From: [Jim Sammet](#)
To: [Rachael Stevie \(CD\)](#)
Cc: [CDS User](#)
Subject: RU 22-00002: East Peak Reasonable Use Variance
Date: Friday, April 22, 2022 4:16:00 PM
Attachments: [RU-22-00002 East Peak Site Plan\(f\).pdf](#)

HYAK PUD PARCEL B

PRELIMINARY SITE PLAN

EXHIBIT A - PROPOSED SITE PLAN

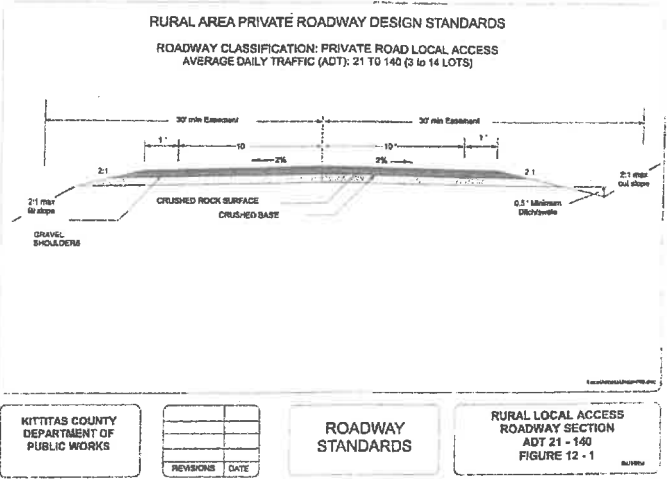
The site plan submitted with the Reasonable Use application differs from the site plan in the approved PUD. The original site plan in the PUD indicates there would be a total of 8 lots with 7 lots assumed from the exhibit to be single family lots and a Multi-Family (Condominium) structure located at the south end of parcel B on lot 8. The site plan submitted with the Reasonable Use application now shows a multi-family structure at the north end of Parcel B and 7 townhome structures located between the Multi Family Structure and the wetland buffer variance sought in the Reasonable Use application. This is a change that affects the existing adjacent single family residences on two sides of Parcel B.

The director should consider zoning, comparable structure size and land use of the surrounding neighborhood in regard to the site plan submitted with the Reasonable Use application. The site plan in the application would locate a large multi-family structure immediately adjacent to single family homes located on the north and west sides of Parcel B. The site plan should consider structure type including density of development in the same manner as Parcel B was originally proposed in the PUD. The density of development should increase to the south towards the Summit East Ski Area Base where several high density multi family buildings are proposed in the PUD. Therefore the Director should consider the following revisions to the site plan as submitted in this Reasonable Use application:

1. The Townhome structures should be located at the north end of Parcel.
2. The Multi-Family structure should be located between the townhomes and

the wetland buffer sought under this Reasonable Use application.

This configuration of the site plan would allow density of development to increase to the south towards the Summit East Ski Area base transitioning from Single Family to Attached Townhome then to Multi Family which will be located adjacent to the existing Sundance Condominiums multi-family structure.

Attached with my comments for the record is a mark-up of the Parcel B site plan depicting the reconfiguration of Parcel B proposed in these comments. Please included the site plan markup with my comments for the record.

Density of development increases towards the base are with the Sundance and Suncrest Condominiums and Condo buildings proposed in PUD
